<b>Device</b>	<b>XMC1100</b>
<b>Marking/Step</b>	<b>EES-AB, ES-AB, AB</b>
<b>Package</b>	<b>PG-TSSOP-16/38, PG-VQFN-24/40</b>

This “Errata Sheet” describes product deviations with respect to the user documentation listed below.

**Figure 1** Clock Selection Diagram for CCU4/CCU8

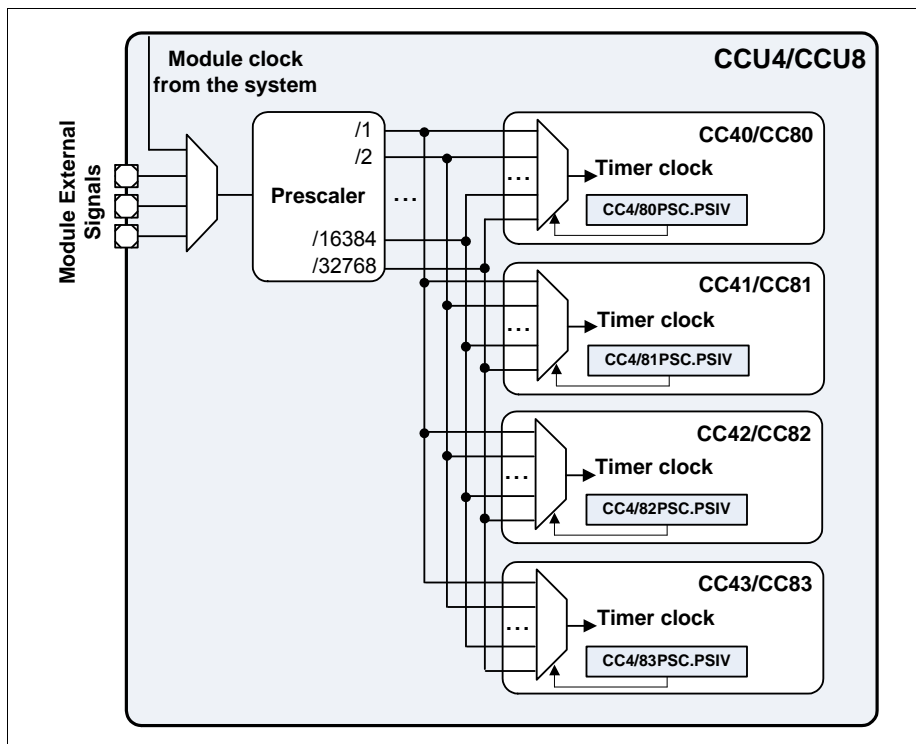
Currently is only possible to use an external signal as Timer Clock when a division ratio of 2 or higher is selected. When no division is selected (divided by 1), the external signal cannot be used.

The user must program the PSIV field of each Timer Slice with a value different from 0000<sub>B</sub> - minimum division value is /2.

This is only applicable if the Module Clock provided by the system (the normal default configuration and use case scenario) is not being used. In the case that the normal clock configured and programmed at system level is being used, there is not any type of constraints.

None.
